**Re: EPA-HQ-OAR-2022-0491; EPA Method 320—Measurement of Vapor Phase Organic and Inorganic Emissions by Extractive Fourier Transform Infrared (FTIR) Spectroscopy, 89 Fed. Reg. 15,101 (Mar. 1, 2024)**

GPA Midstream Association (“GPA Midstream”) appreciates this opportunity to submit comments on the U.S. Environmental Protection Agency’s (“EPA”) proposed rulemaking, Measurement of Vapor Phase Organic and Inorganic Emissions by Extractive Fourier Transform Infrared (FTIR) Spectroscopy, 89 Fed. Reg. 15,101 (Mar. 1, 2024).

Re: Revision to USEPA Method 320

Re: Revision to USEPA Method 320

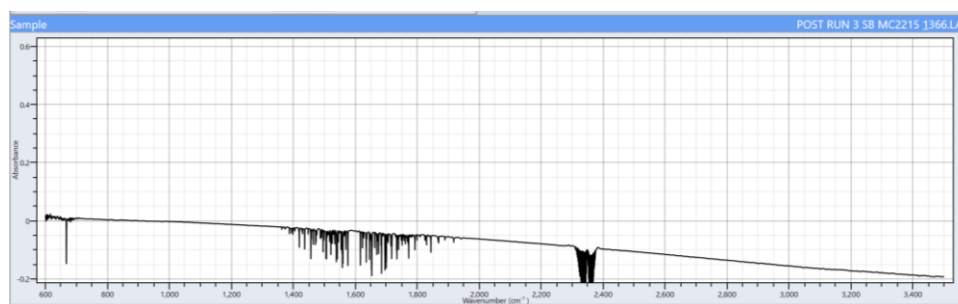
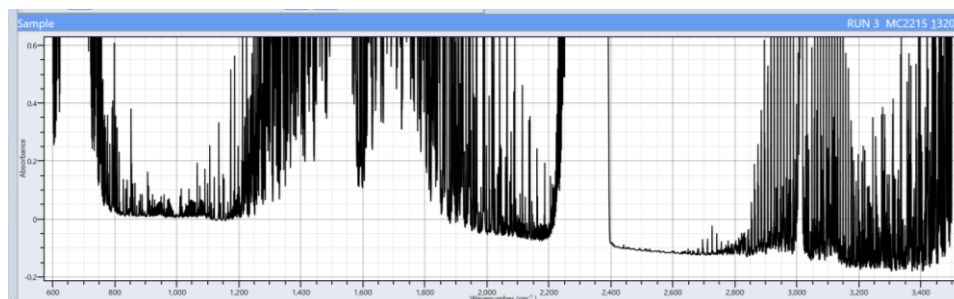
See example spectrum below. In this spectrum, there are three compounds all over lapping with the others: propane, butane and HCl. For those trained in IR gas analysis, the doublets of the HCl spectrum are obvious. If the baseline must stay within say 5%, this is clearly a violation of that statement. Far worse though is that the propane and/or the butane are sitting on top of the other. In this case, there is a baseline shift that is approximately half of the large peak, or 0.3 abs (which is 50% of the light absorbed). So, if we assume the baseline is the butane going up to 0.3 abs, then the propane is sitting on top of a huge baseline shift. So, the propane measurement cannot be made if we stipulate a baseline criterion to the method. In this case, both are 100 ppm, levels that are exceeded all the time. Both are easily measured by the software. This demonstrates that no overriding baseline criterion should be placed on IR data.

Additionally, any baseline shift that is caused by particulate on the mirrors or FTIR instability should not be removed by re-zeroing the analyzer once a measurement is started. **This is the worst mistake a source tester could make.** Instead, they should complete the test and then run N<sub>2</sub> at the end to get a spectrum of the particulate matter or baseline shift. Then they would add that to their method since particulate spectra and baseline shifts due to FTIR performance are linear at any loading level since they are broad absorbances or shifts. This “new calibration” will provide an exact correction for the particulate or baseline instability as it is increasing throughout the measurement. The baseline shift in the data below would easily be fixed (all throughout the run) by adding the single N<sub>2</sub> spectrum at the end of the measurement back into the method.

Baseline drift is important to watch and make sure it is being handled properly in the analysis but there is not an appropriate level for all applications and as such should not be part of this method. The better thing to do is to re-perform an MDL test if much of the light is actually lost due to particulate. Again, that could be performed by collecting a series of N<sub>2</sub> spectra.
